### APPEAL SUMMARY

**Status:** Decision Rendered - Reconsideration of ID 22007

<b>Appeal ID:</b> 22204	<b>Project Address:</b> 5060 N Greeley Ave
<b>Hearing Date:</b> 12/11/19	<b>Appellant Name:</b> Dannon Canterbury
<b>Case No.:</b> B-010	<b>Appellant Phone:</b> 503-928-6965
<b>Appeal Type:</b> Building	<b>Plans Examiner/Inspector:</b> Brian McCall
<b>Project Type:</b> commercial	<b>Stories:</b> 5 <b>Occupancy:</b> S-2, A-2, A-3, B <b>Construction Type:</b> III-A, I-A
<b>Building/Business Name:</b> adidas North Building	<b>Fire Sprinklers:</b> Yes - Throughout
<b>Appeal Involves:</b> Reconsideration of appeal	<b>LUR or Permit Application No.:</b> 18-188494-CO
<b>Plan Submitted Option:</b> pdf [File 1] [File 2] [File 3] [File 4] [File 5]	<b>Proposed use:</b> Office, Assembly, Parking

**Alternate 2 hour fire rated floor / ceiling assembly: Granted as proposed**

3 ENLARGED PLAN - SHAFT 04 - LEVEL 03  
SCALE: 1/2" = 1'-0"

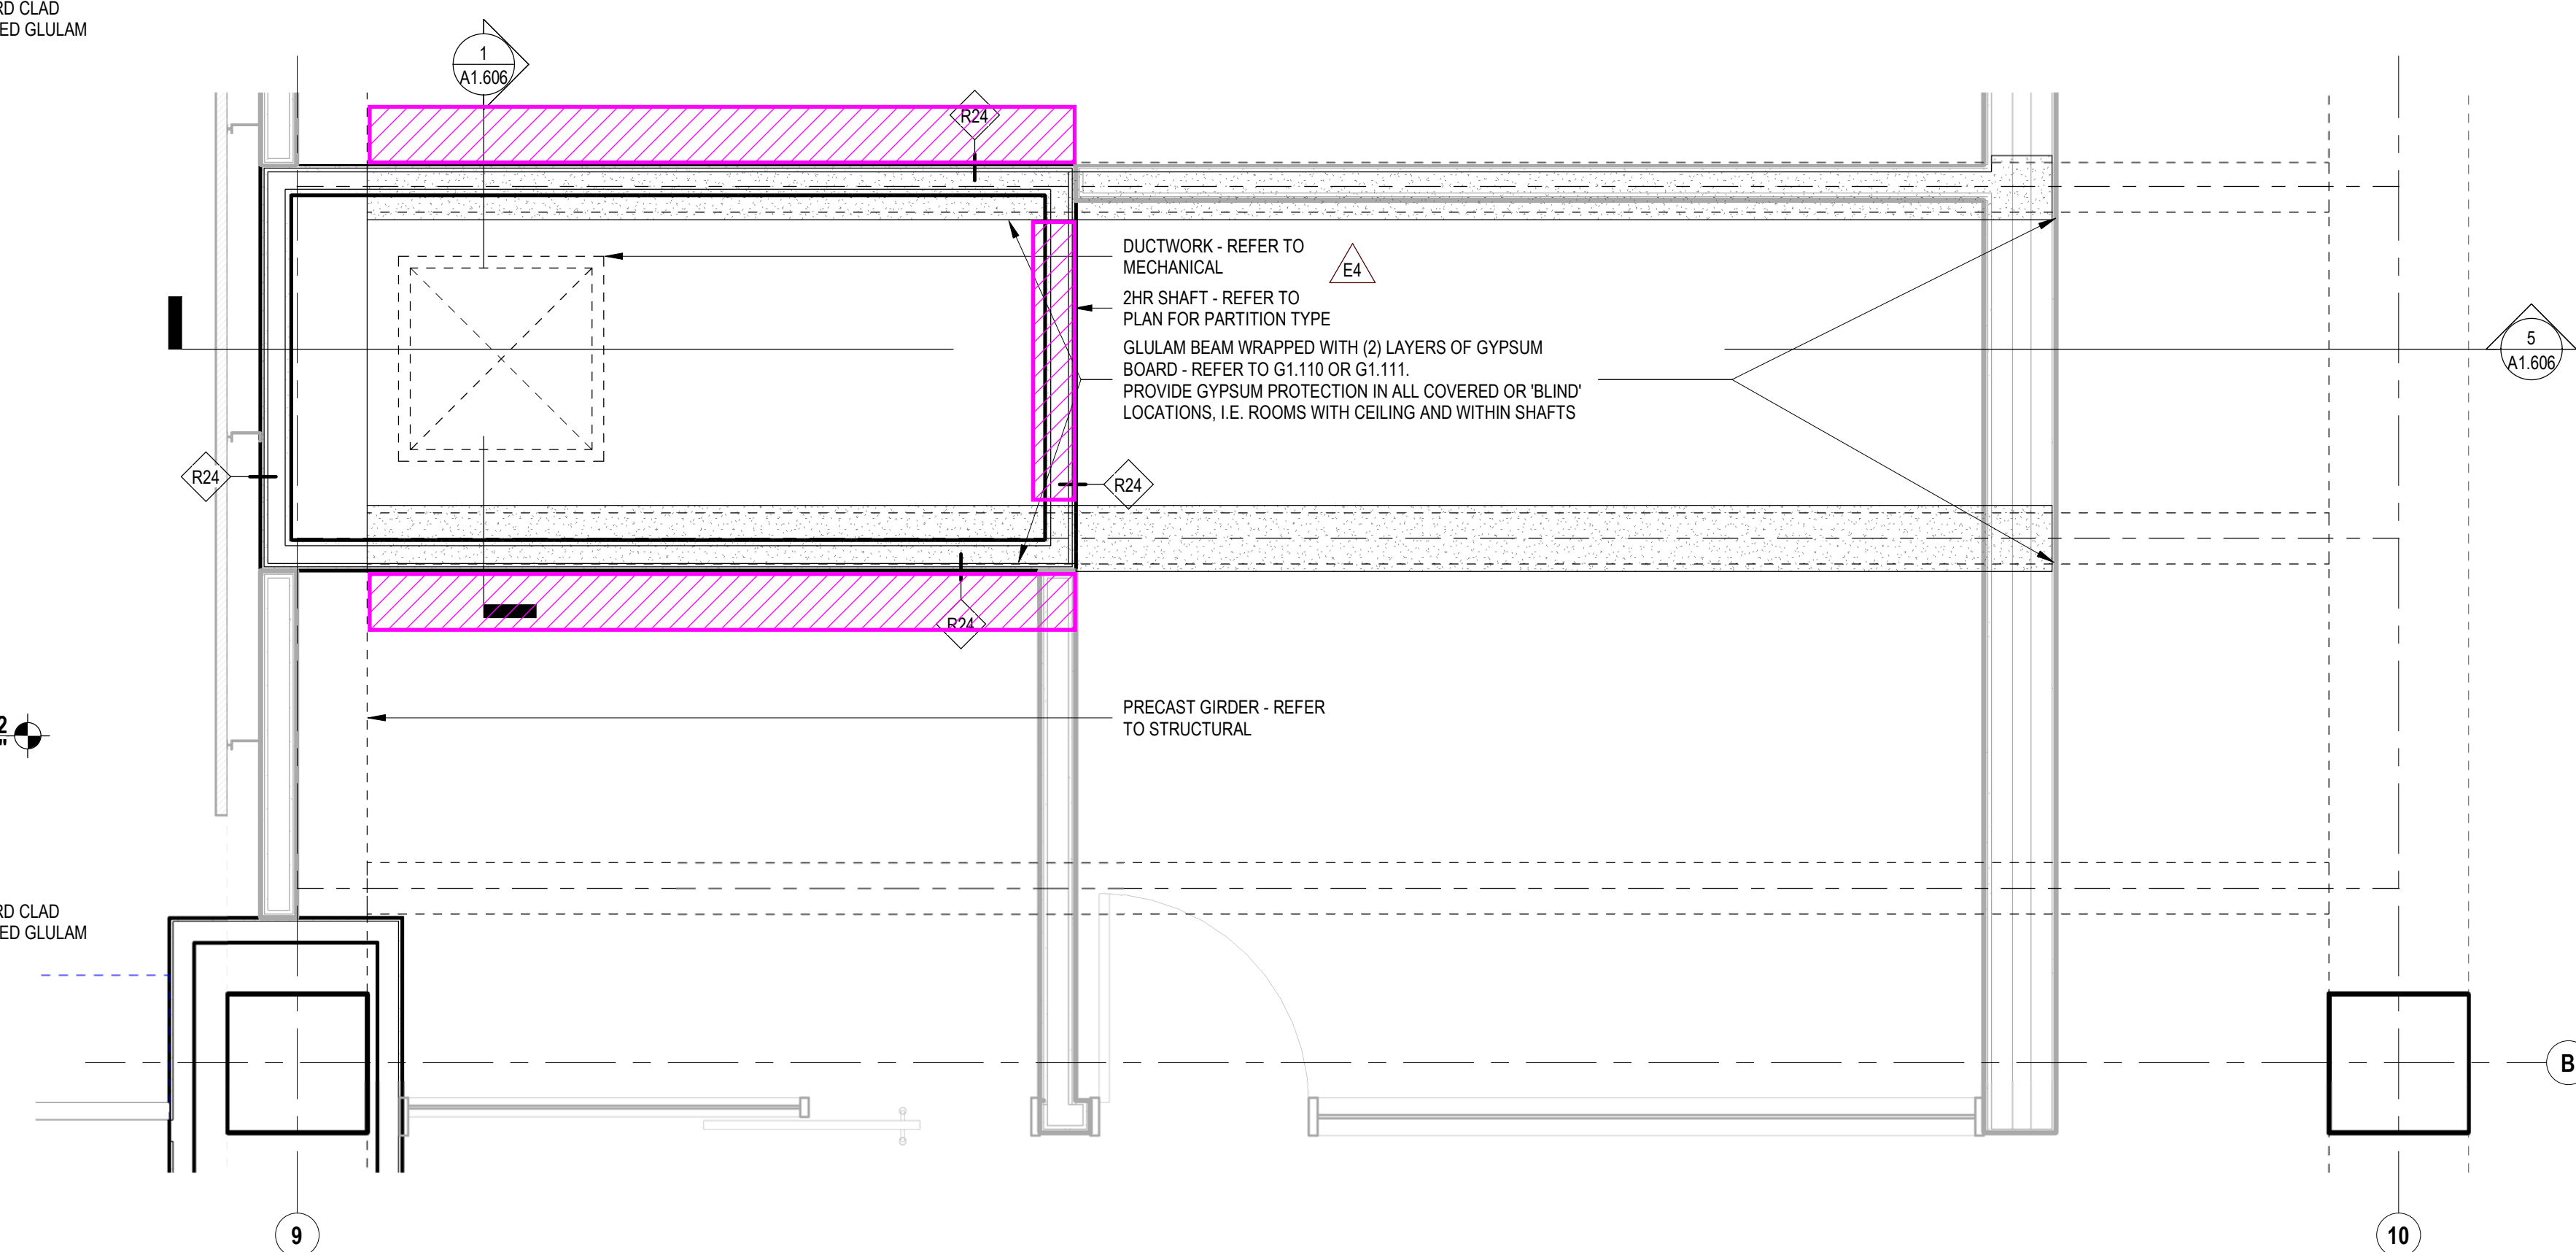
<b>Code Section</b>	OSSC 707.5 and 713.4
<b>Requires</b>	<p>OSSC 707.5.1 requires that supporting construction for a fire barrier be protected to afford the required fire-resistance rating of the fire barrier supported.</p> <p>OSSC 713.4 requires shaft enclosures to have a fire-resistance rating of not less than 2 hours where connecting four stories or more.</p>
<b>Proposed Design</b>	<p>This III-A construction type building consists of a structural frame of precast concrete columns and girders (3hr rated as presented during permit), glulam beams (1hr as presented during permit), 3-ply CLT (unaccounted contribution), and a concrete topping slab (1hr as presented during permit). Within the floors there are a number of shafts that are four stories or more which will be enclosed with a 2hr UL listed shaft wall assembly. Those shafts are structurally supported on either the 3hr rated precast concrete frame or 1hr rated glulam beams protected with two layers of 5/8" type 'x' gypsum board, raising their rating to 2hr (per NDS table 4.4.2.1).</p> <p>The presented design is to revise the extents of that gypsum wrap to include it at the glulam beams within the shafts and above spaces with ceiling but exclude it in the open office and lobby spaces where the beams are exposed to view.</p> <p>RECONSIDERATION:</p> <p>In addition to previous submission, the proposal is to provide additional protection to areas of the floor structure which directly support the 2-hour rated fire barriers at shaft locations. As previously indicated, floor structure is 3-ply CLT with concrete topping providing a 1-hour rating. At locations supporting 2-hour rated fire barriers, 2 layers of 5/8" type 'x' gypsum board would be added to the</p>

CLT decking to increase the floor structure's fire-resistance rating to 2-hours, per NDS table 4.4.2.1. See attached section drawings A1.603-A1.607 showing locations for consideration.

**Reason for alternative** The purpose of a shaft is to confine a fire (smoke, heat, and hot gases) to the floor of origin or preventing the fire from spreading to other levels. This purpose is met by protecting the glulam beams to achieve a 2hr fire-resistance within the shaft and in all covered or blind conditions where a fire could potentially propagate prior to initiating egress of the main spaces or affecting the structural integrity of the members and shaft.

The selected structural system generally limits the glulam beam spacing to 5'-0" on center, while shafts which house large mechanical ducts need to be larger than 5'-0" for fittings, dampers, etc. Spanning between concrete girders, some glulam beams exist entirely within the 2hr rated shafts and are rated to 2hrs (see attached reflected ceiling plans A1.701-A1.704). In locations where the glulam beams extend past the 2hr shaft enclosure, they are rated to 1hr fire-resistance, similar to the exposed glulam beams elsewhere in the project.

The Administrative Appeal Board finds that the information submitted by the appellant demonstrates that the approved modifications or alternate methods are consistent with the intent of the code; do not lessen health, safety, accessibility, life, fire safety or structural requirements; and that special conditions unique to this project make strict application of those code sections impractical.
